SUBMITTAL COVERSHEET Nanuet UFSD –Phase 3 Projects

SHOP DWGS MIDDLE SCHOOL PIPING / COORDINATED WITH GPS SCANNING

SAGE LOG NO. M-45.1

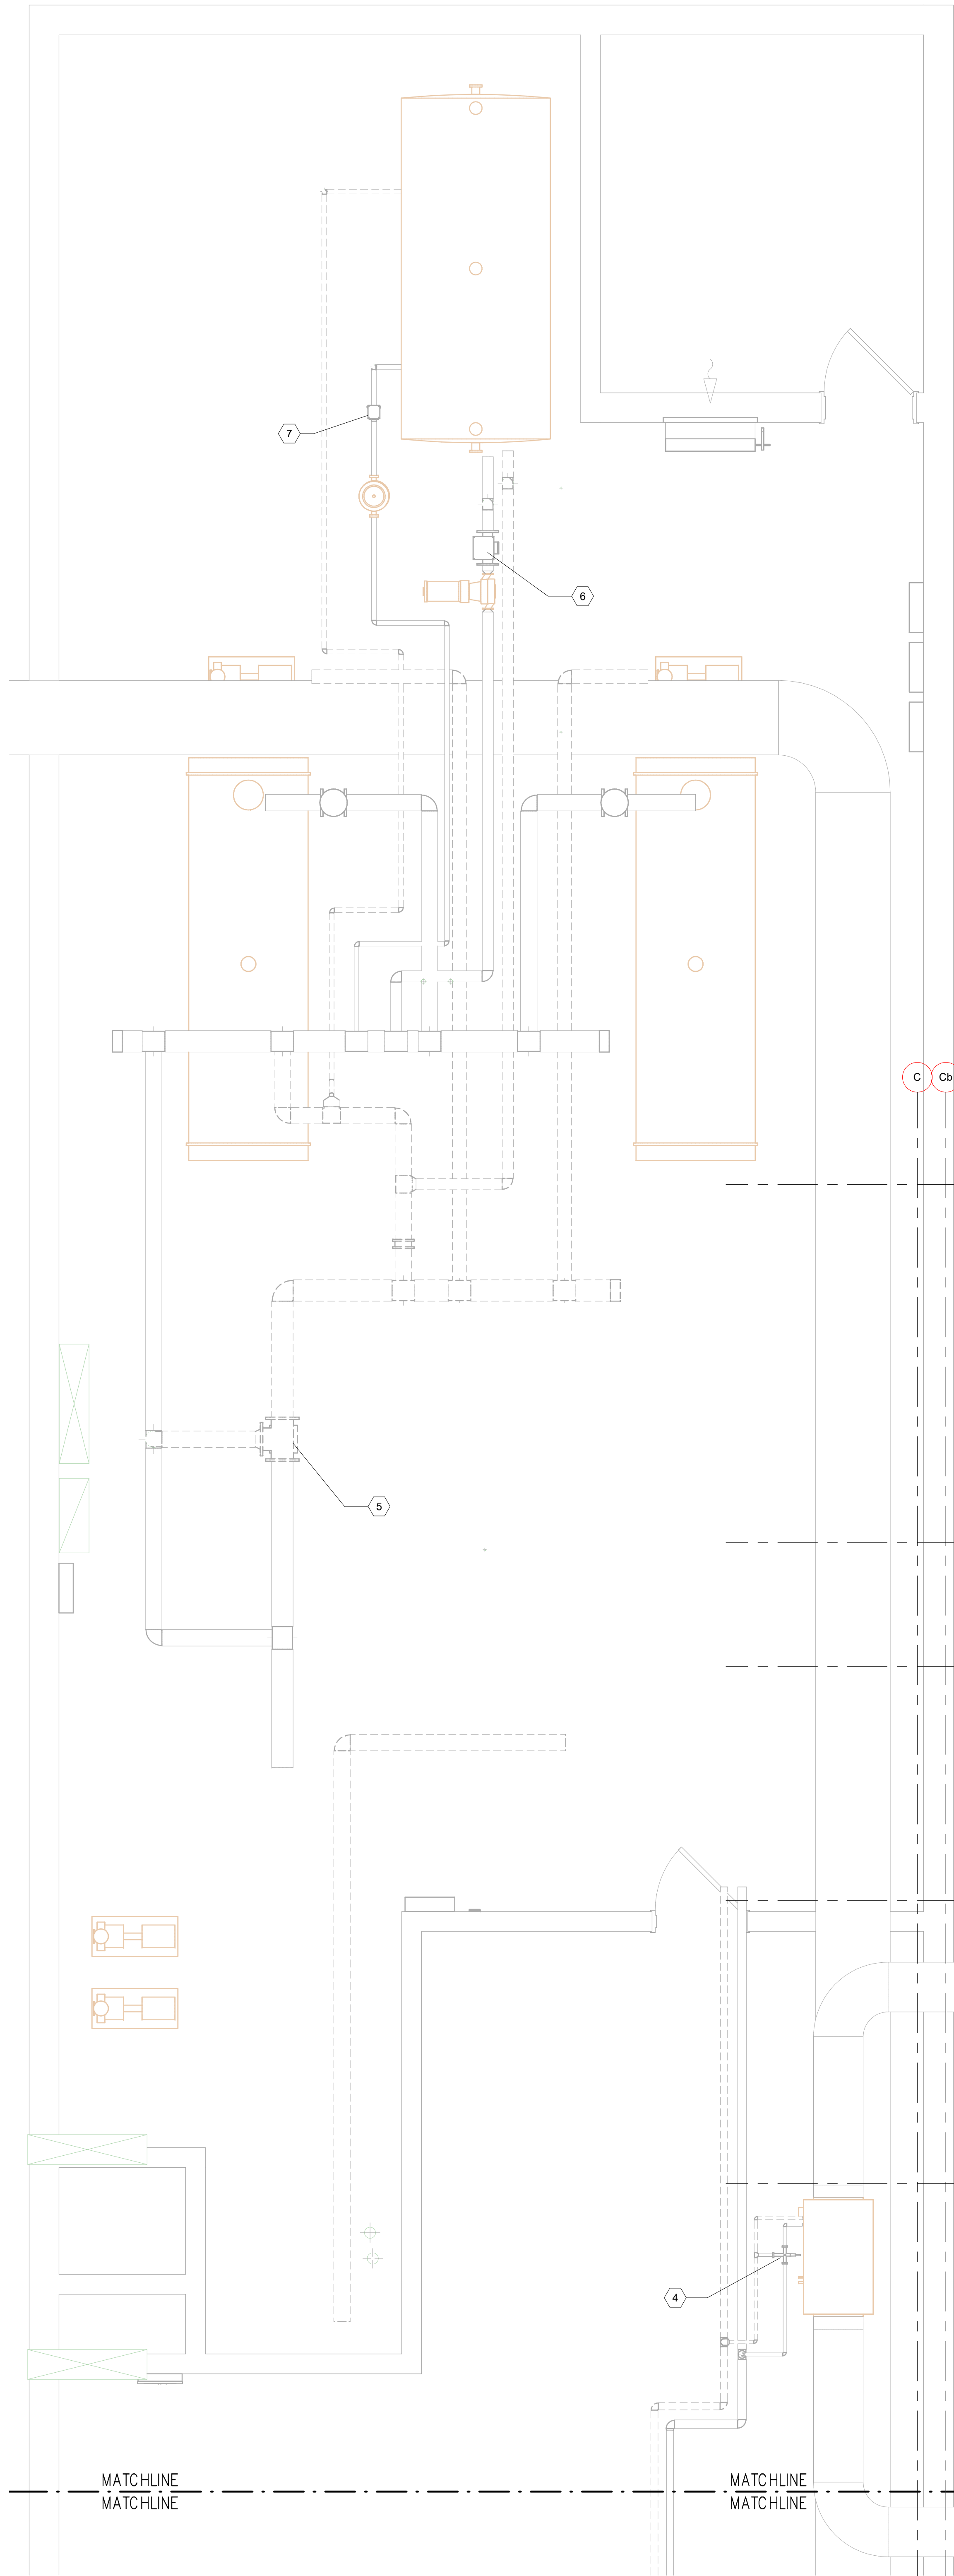
I believe this is a typo. The listed above finished floor height for the HWS piping serving the unit ventilators should be within the pipe enclosure along the wall.

I believe this is a typo. The listed above finished floor height for the HWS piping serving the unit ventilators should be within the pipe enclosure along the wall.

I believe this is a typo. The listed above finished floor height for the HWS piping serving the unit ventilators should be within the pipe enclosure along the wall.

2
MP-BM
SCALE: 3/8" = 1'-0"

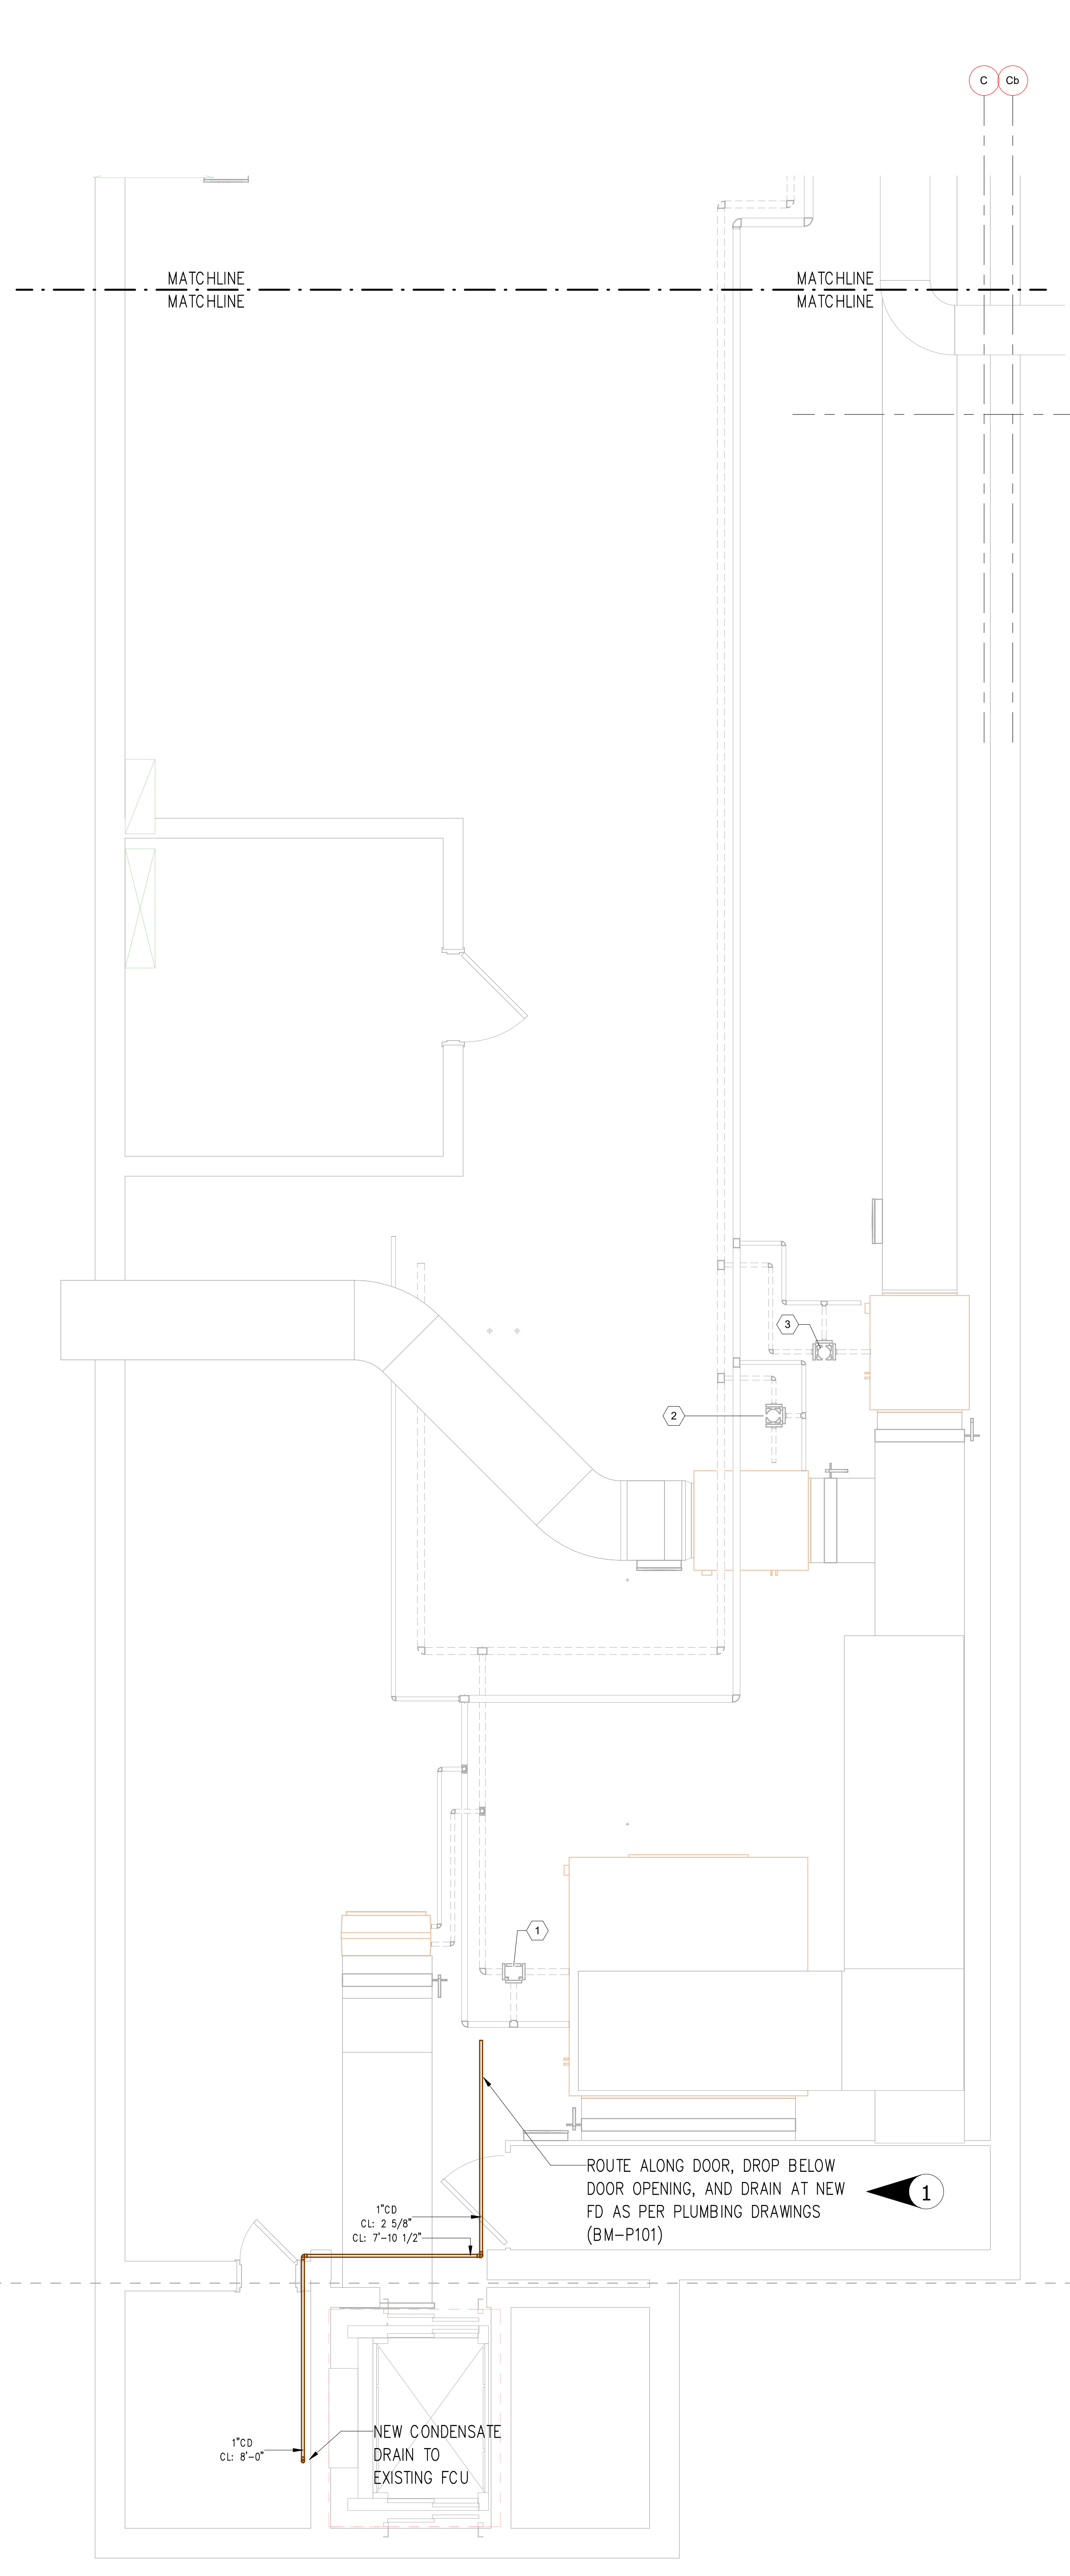
I believe this is a typo. The listed above finished floor height for the HWS piping serving the unit ventilators should be within the pipe enclosure along the wall.
